APPEAL SUMMARY

Appeal ID: 20272	Project Address: 9101 SE Flavel St
Hearing Date: 4/17/19	Appellant Name: Mildred White
Case No.: B-016	Appellant Phone: 5032534283
Appeal Type: Building	Plans Examiner/Inspector: Kent Hegsted
Project Type: commercial	Stories: 1 Occupancy: F-1 Construction Type: V-B
Building/Business Name:	Fire Sprinklers: No
Appeal Involves: Reconsideration of appeal, occ Change from S-1 to F-1	LUR or Permit Application No.: 18-283675-CO
Plan Submitted Option: pdf [File 1] [File 2] [File 3] [File 4] [File 5] [File 6] [File 7] [File 8] [File 9]	Proposed use: cannabis extraction facility

High Horse Warehouse TI

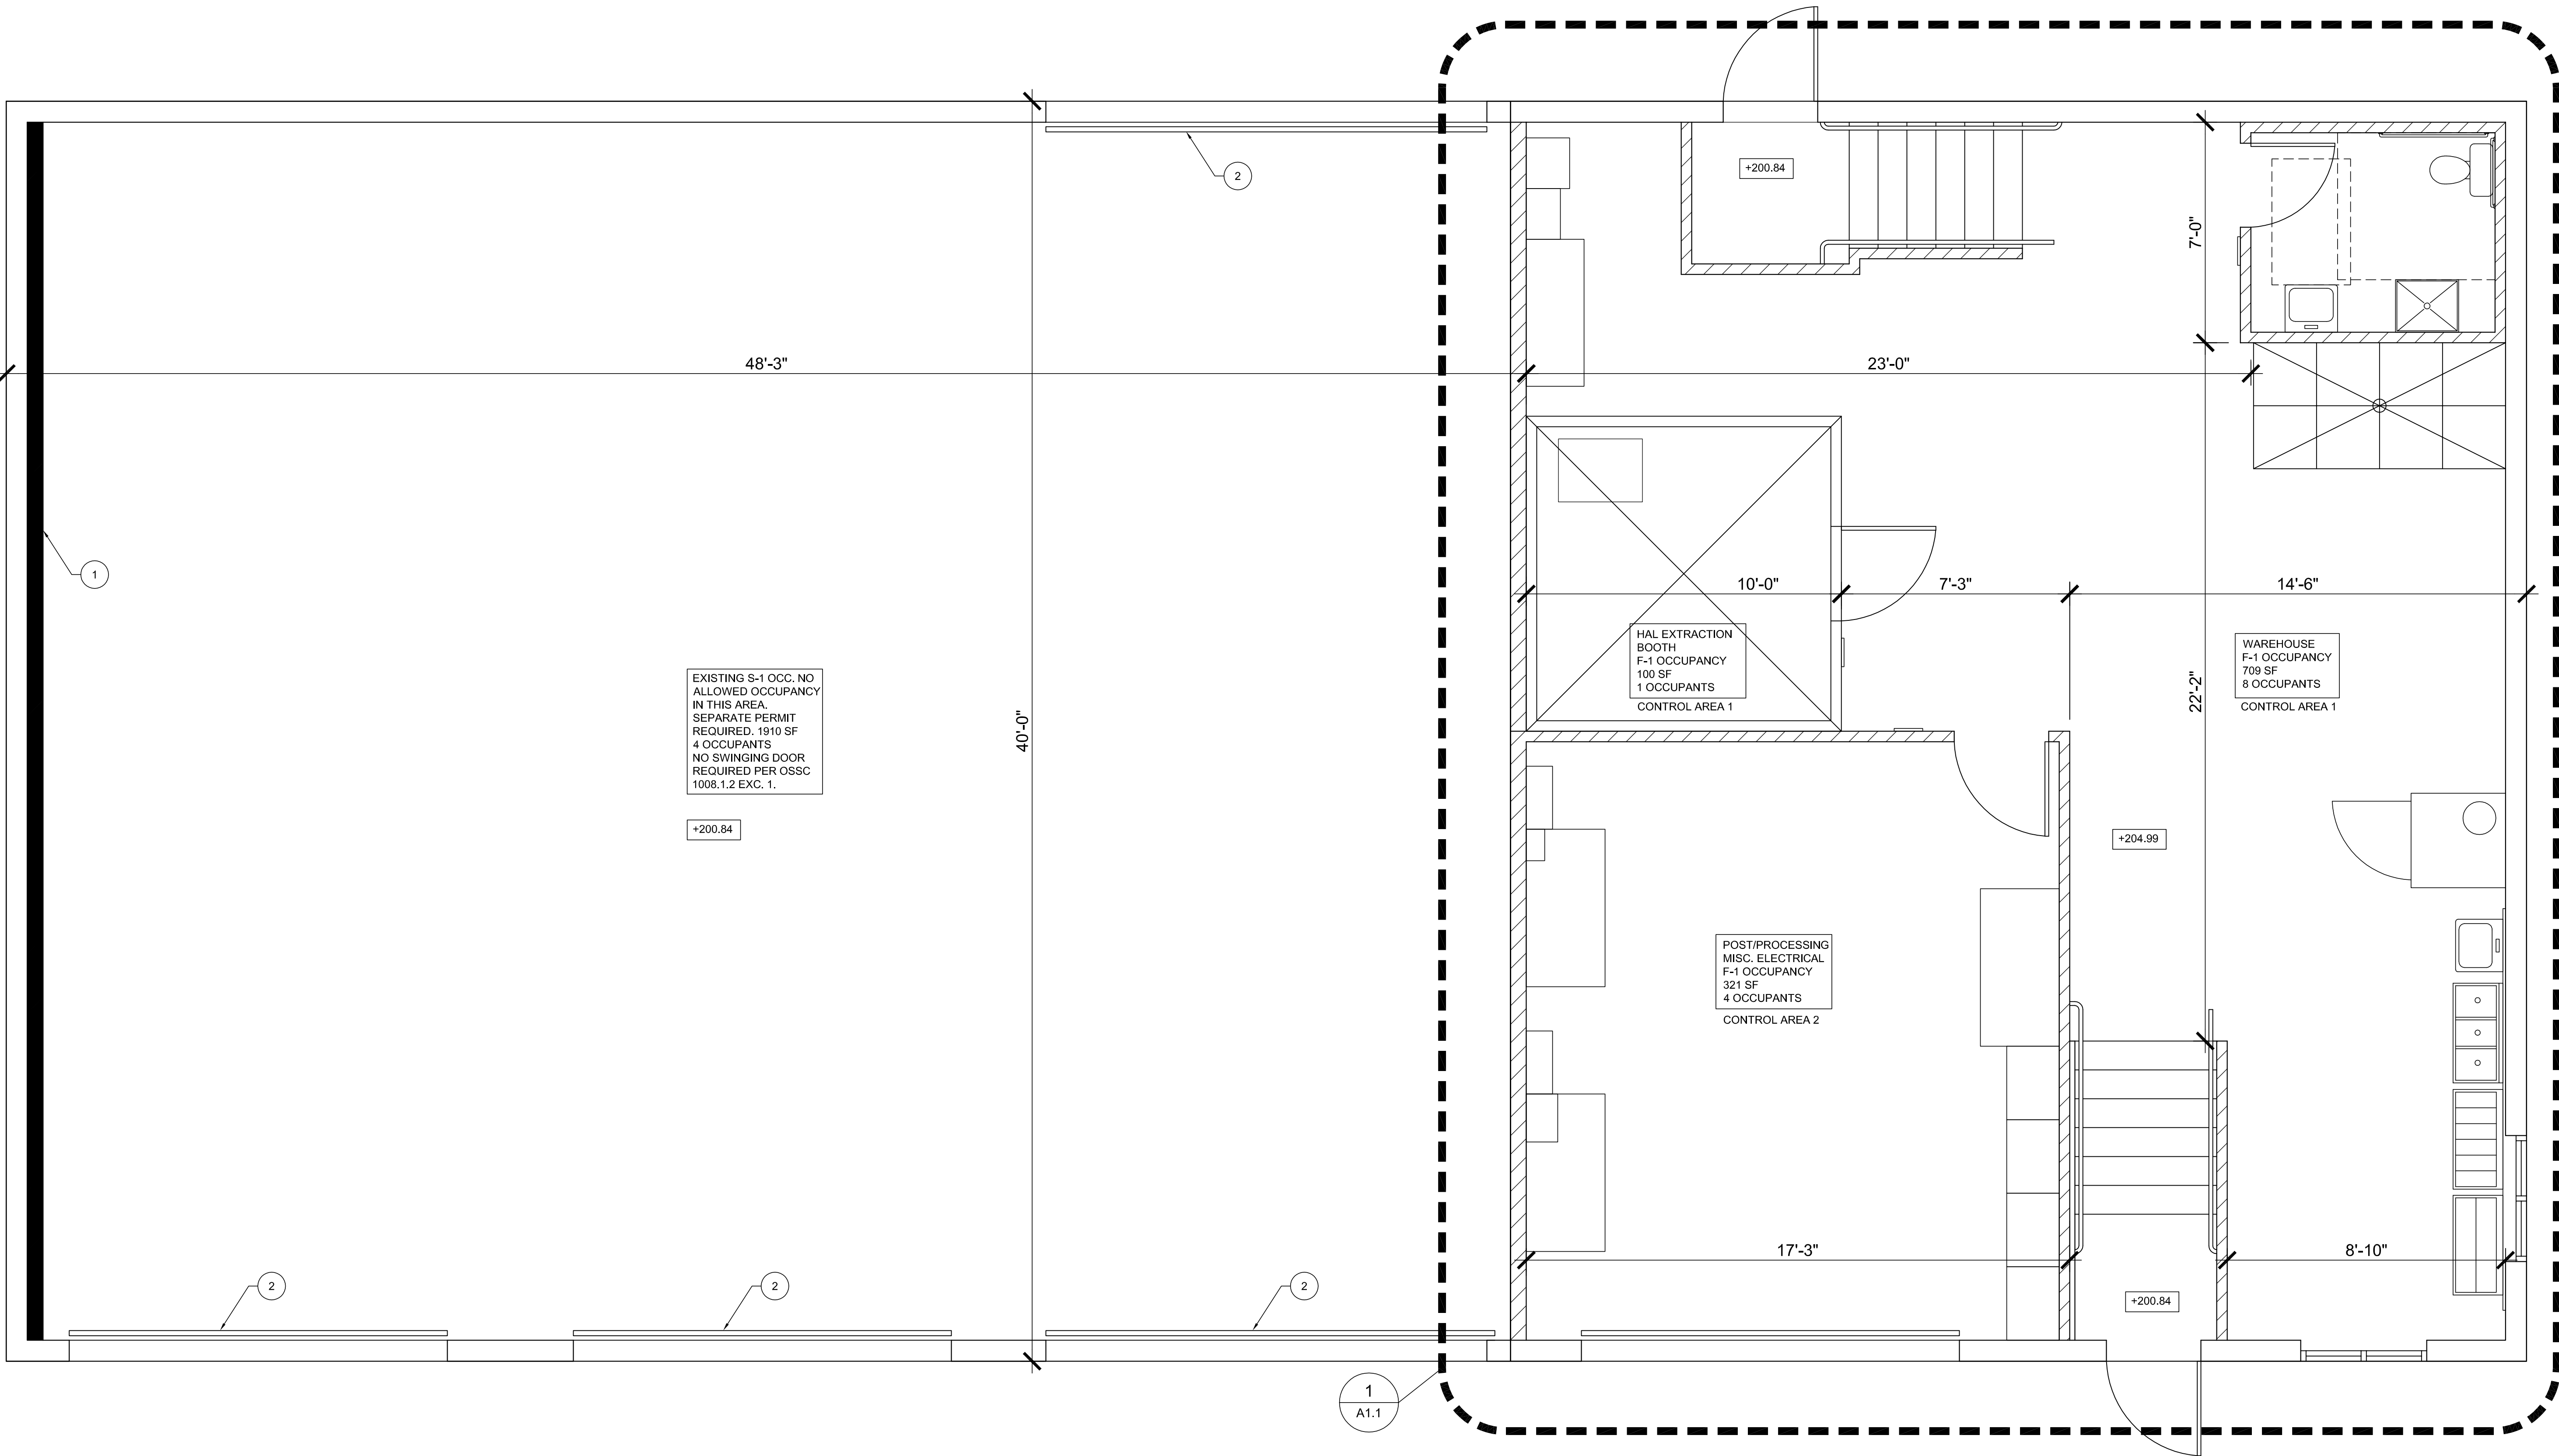
1. Alternate 2 hour assembly for existing exterior wall at property line: Hold for additional information.

5. 1-HOUR FIRE WALL @ PARAPET

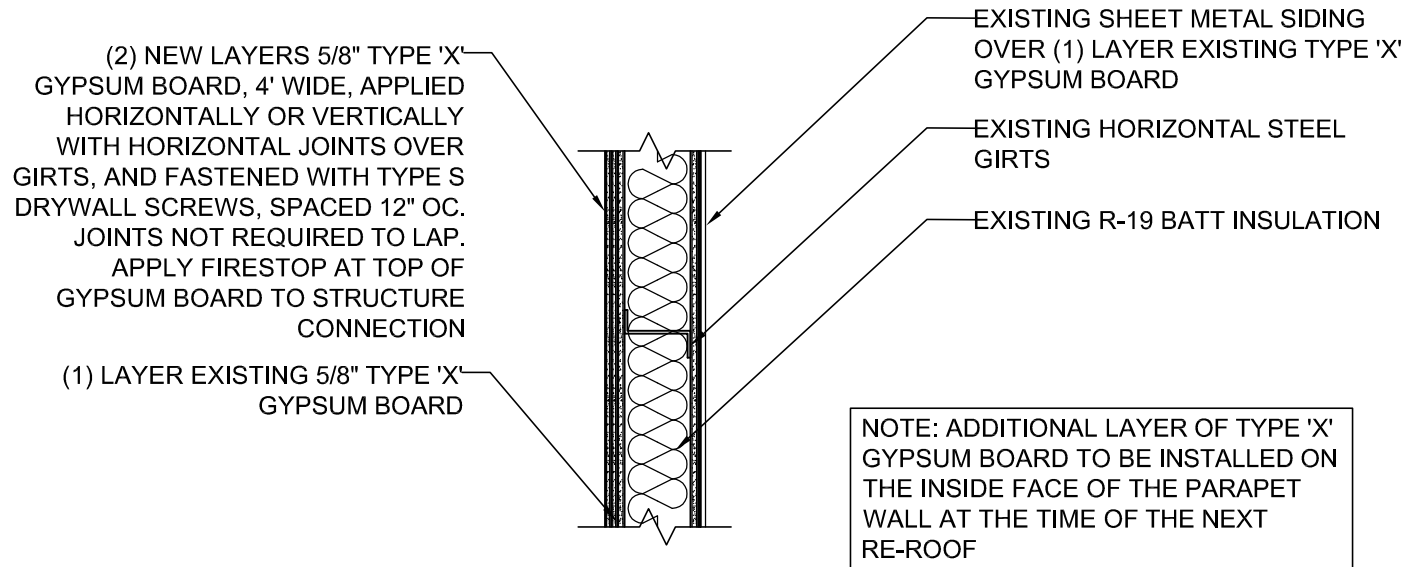
Code Section	Table 602, 705.5
Requires	Buildings of V-B construction and S-1 or F-1 occupancy that are located with 5' of the property line must have a two-hour fire rated construction and shall be rated for exposure to fire from both sides. The west wall of the existing building is located within 5' of the property line.
Proposed Design	<p>The original appeal was approved. This appeal is for reconsideration of a revised detail.</p> <p>Original approved appeal text: Current wall is one hour rated. A tilt up construction of steel stud and gypsum board will be erected inside the building at the exterior wall to achieve two-hour rating. Proposed design keeps the parapet portion of the wall "as-built" at the existing one hour rated construction. Included with this submission is a site plan, site photo and section at the parapet from the original permit drawings.</p> <p>Reconsideration appeal text: The existing building is a pre-engineered metal building. The exterior walls are of noncombustible construction, with interior walls of both noncombustible and combustible construction. The primary structural frame is also noncombustible. The existing west exterior wall is one-hour rated and has no openings. The proposed design is to retain the existing assembly on the exterior side of the building but add two additional layers of 5/8" type 'x' gypsum board on the interior, for a total of three (3) layers of 5/8" type 'x' gypsum board on the interior. Please see attached detail 10/A1.2.</p>

The requirement for fire rating is due to proximity to the property line and potential for an adjacent building to spread fire. As mentioned above, the project building structural components, and exterior wall assemblies, are non-combustible. The proposed detail is like UL Design No. W413 (see attached) for a two-hour rating, except that we have proposed to also have one layer of fire rated gypsum board on the exterior as well.

Original appeal was granted provided that an additional layer of Type X gypsum board is added to the inside face of the parapet wall at the time of the next re-roof. This note has been added to the drawings for this permit. See detail 10/A1.2.

NOTE: FRAMED WALL ONLY OCCURS ABOVE EXISTING TWO-HOUR RATED CMU STEM WALL THAT IS APPROXIMATELY 4'-0" HIGH. FIELD VERIFY. IF ANY PORTION OF FRAMED WALL OCCURS BELOW 4'-0" A.F.F., EXTERIOR RATED 5/8" DENSGLASS FIREGUARD SHEATHING MUST BE INSTALLED IN LIEU OF GYPSUM BOARD TO MEET FEMA FLOOD HAZARD MATERIAL REQUIREMENTS
